Access Compliance Report

Public Rights-of-Way

Intersection ID: 27535	Main Street: COUNTRY_SQUIRE_CT	Cross Street: FAWN_HILL_RD	Location: SE
ADA ID: 56572064754E	Ramp Type: BlendTrans1	Initial Pass/Fail: Fail	Overall Compliance: No
		Severity Score: 10

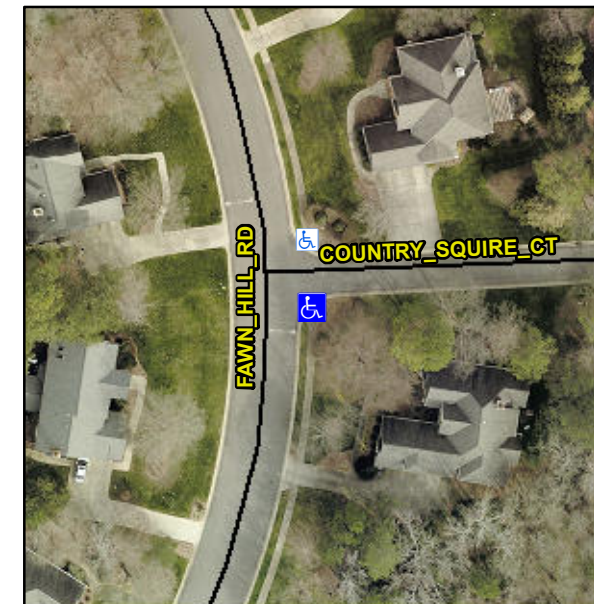
Not Found, R304.5.1, R304.5.3

Compliance	Description	Data	Compliance	Description	Data
N/A	Ramp Length (in)	48.0	Yes	BlendTrans Slope (%)	1.7
No	Ramp Width (in)	46.0	No	BlendTrans XSlope (%)	3.6
N/A	Flare Type LT	N/A	N/A	Flare Type RT	N/A
N/A	Flare Slope LT (%)	N/A	N/A	Flare Slope RT (%)	N/A
N/A	Flare Traversable LT?	N/A	N/A	Flare Traversable RT?	N/A
N/A	Landing Length (in)	N/A	N/A	DWS Provided?	N/A
N/A	Landing Width (in)	N/A	N/A	DWS Contrast?	N/A
N/A	Landing Slope (%)	N/A	N/A	DWS Length (in)	N/A
N/A	Landing X Slope (%)	N/A	N/A	DWS Full Width?	N/A
N/A	Landing Curb? (Y/N)	N/A	N/A	DWS Offset (in)	N/A
N/A	Shared Landing?	N/A			
N/A	Gutter Ponding?	N/A	N/A	Gutter Slope (%)	N/A
N/A	Gutter Lip Ht (in)	N/A	N/A	Gutter X Slope (%)	N/A
N/A	Painted X Walk1?	No	N/A	Painted X Walk2?	N/A
	X Walk 1 Direction	To N		X Walk 2 Direction	N/A
	X Walk 1 Width (in)	N/A		X Walk 2 Width (in)	N/A
	X Walk 1 Slope (%)	8.0		X Walk 2 Slope (%)	N/A
	X Walk 1 X Slope (%)	0.5		X Walk 2 X Slope (%)	N/A

N/A	Ramp inside XWalk1?	N/A	N/A	Ramp inside XWalk2?	N/A
	Road Slope (%)	0.5		Clear Space?	N/A
	Road X Slope (%)	8.0	N/A	Clear Space to XWalk (in)	N/A
N/A	Any Obstructions?	N/A	N/A	Storm Grate/Utility Hazard?	N/A
	Obstruction Type			Storm Grate/Utility Type	
		N/A			N/A
			Yes	Surface Condition? (G/P)	Good
			No	Curb Slope (%)	6.7

Remove & Replace Curb Ramp With Two New Directional Ramps or Equivalent.
